## 1114, 1116, 1117, 1118 Wireless Modules September 2012

### Hardware Update

The 1114 Zone Expander, 1116 Relay Module, 1117 Annunciator, and 1118 Remote Indicator are being manufactured with updated Level C hardware. The updated hardware will begin shipping as current stock is depleted and is estimated to occur mid to late October 2012.

##### Optional External DC Plug-in Power Supply

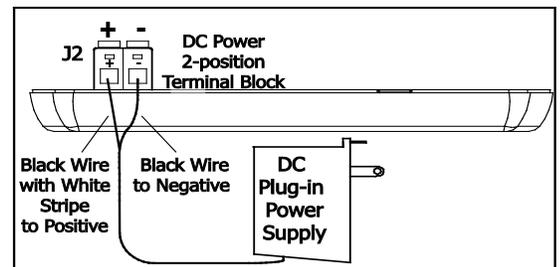
The 1114-1118 Wireless Modules with updated Level C hardware now provide a two-position terminal block as the optional DC power connection (J2) when the CR123 battery is not used. Previous to this update, a barrel style plug-in connector was used.

3. Wire the power supply to the J2 terminal block. Connect the Black wire with the White stripe to the positive terminal and the Black wire to the negative terminal. See Figure 4.
4. Snap the cover back into place.
5. Plug the Model 376 power supply into a 110 Volt AC outlet.
